**SECURE DOCUMENT STORAGE FACILITY  
BAGHDAD, IRAQ**

**SUSTAINMENT ASSESSMENT**

**SIGIR PA-08-166  
OCTOBER 20, 2009**

Figure 1. Strengthening columns

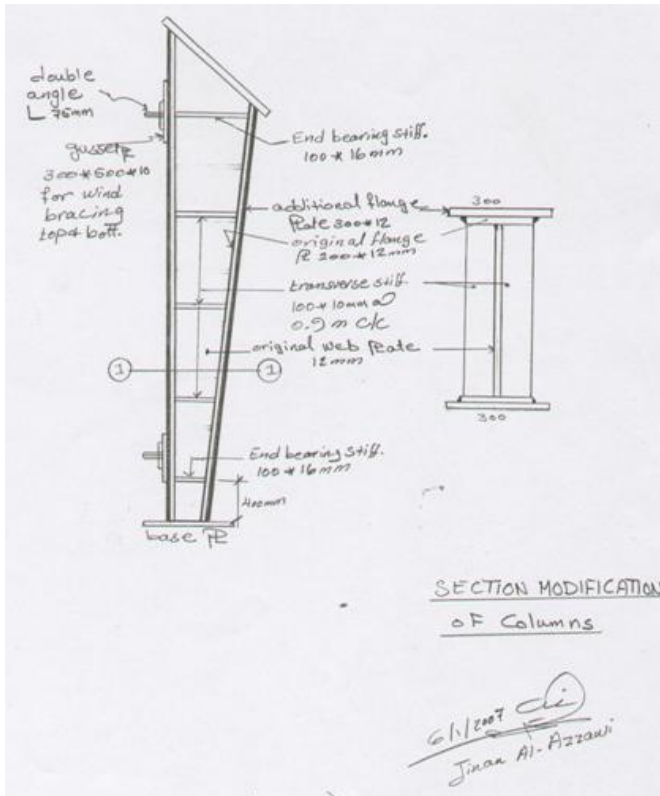
After the December 2006 structural failure, the contractor performed an evaluation and proposed a revised design in January 2007. Specifically, the contractor proposed reinforcing the structure to accommodate the design deficiencies. The proposed solution consisted of the following:

- adding coverplates and stiffeners to the steel frame (Figure 1)
- placing collar ties at each frame
- adding an additional column at the center of each frame
- providing a lateral-load resisting system for the structure (Figure 2)

It appeared that the additional reinforcement addressed the structural issues with the main steel framing; however, the additional support columns may have created issues with the other structural elements. The initial design calculations do not appear to include the additional load from the steel framing. Since the bay spacing<sup>11</sup> for the metal building does not align with the column spacing for the reinforced-concrete beam, the additional steel support columns are located at various points along the reinforced-concrete beam span. This lack of alignment creates additional bending and shear in the concrete beam. No additional calculations were provided to determine if the reinforced-concrete beam has adequate capacity to carry the additional load from the steel framing.

**Figure 3. Three-dimensional model of contractor-proposed improvements (Courtesy of GRC)**

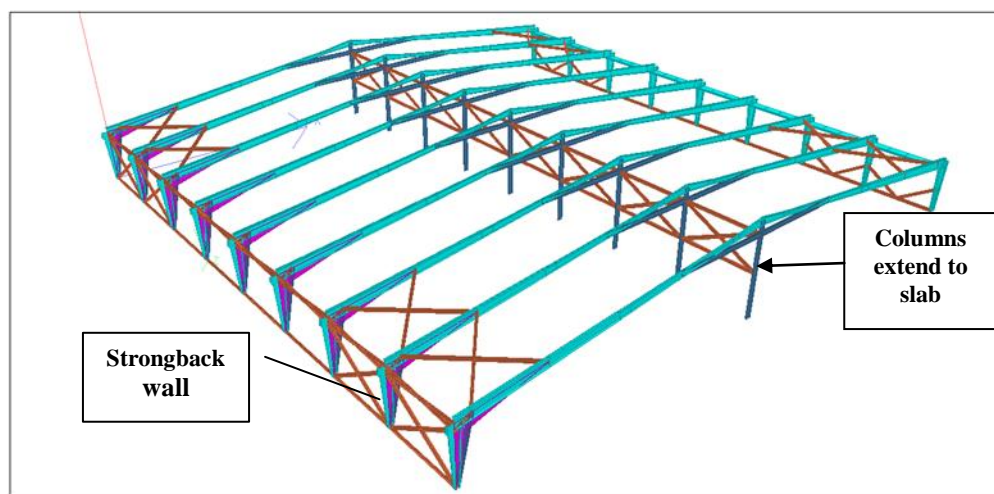
The contractor provided a revised design submittal in January 2007 to correct the design deficiencies that led to the structural failure. In July 2007, the GRC quality assurance (QA) representative documented examples of the building not being constructed in accordance with the planned structural improvements of January 2007. On 26 July 2007, a GRC structural engineer performed an inspection of the construction to date. The GRC structural engineer issued an observation report, which identified several construction deficiencies; all structural work again stopped while the contractor performed another structural evaluation. In September 2007, the contractor presented GRC with structural improvements, including a structural analysis indicating that the proposed improvements would provide a stable structure under eight different loading conditions. The proposal included a row of columns to be constructed along the centerline of the facility, as well as other strengthening improvements, such as corner bracing, cross bracing, and a strongback<sup>13</sup> wall (Figure 3).

Figure 3 illustrates the proposed new steel columns along the centerline, extending to the floor. However, by this time, the interior vault rooms had already been constructed, including a reinforced-concrete beam and partition wall running the length of the building, beneath the centerline of the steel frames. Based upon review of the October 2007 QA reports, it appeared that the contractor performed a modified approach to placing the columns. A base plate was placed on the top of the reinforced-concrete beam, and the columns were welded to the base plate (Site Photo 3). Consequently, this model and corresponding structural analysis do not account for the additional load to the reinforced-concrete beam, supporting columns, and foundation.

Figure 4. Poured concrete columns within block wall (Courtesy of GRC)

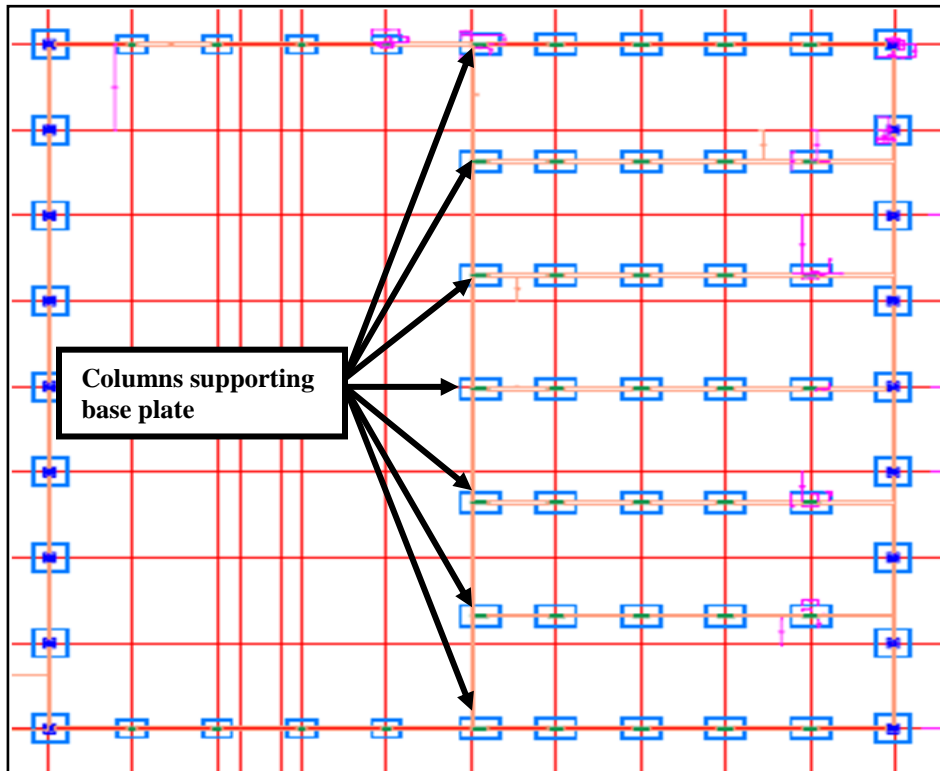
A concrete masonry partition wall is located beneath the reinforced-concrete beam (Figure 4). If the reinforced-concrete beam deflects under load, some load sharing between the beam and the wall will occur. Reviewing the daily QA reports, SIGIR identified that the blocks used to create this wall were of poor quality, which by themselves, would be of questionable capacity to hold any significant load. The presence

of the beam indicates that the original designer did not anticipate the wall to be a structural element.

**Site Photo 15. Contractor replaced previously cracked and buckling floor tiles (See Site Photo 8 for original condition of bathroom floor.)**

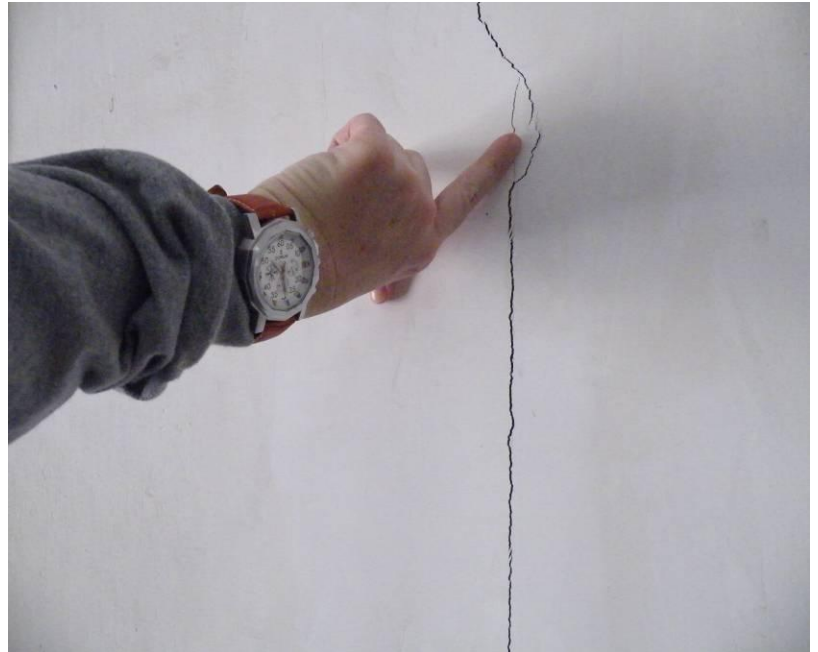
During the 11 March 2009 site visit, SIGIR observed the contractor in the process of repairing the floor in one of the four bathrooms. The contractor had not addressed the remaining deficiencies.

However, during the 27 September 2009 site visit, SIGIR toured the entire facility and determined that the contractor had remedied the previously identified warranty deficiencies (Site Photo 15). The SDSF facility manager stated that the GRC IZ Resident Office did an excellent job of requiring the contractor to return to the facility three times to ensure that each warranty issue was adequately addressed.
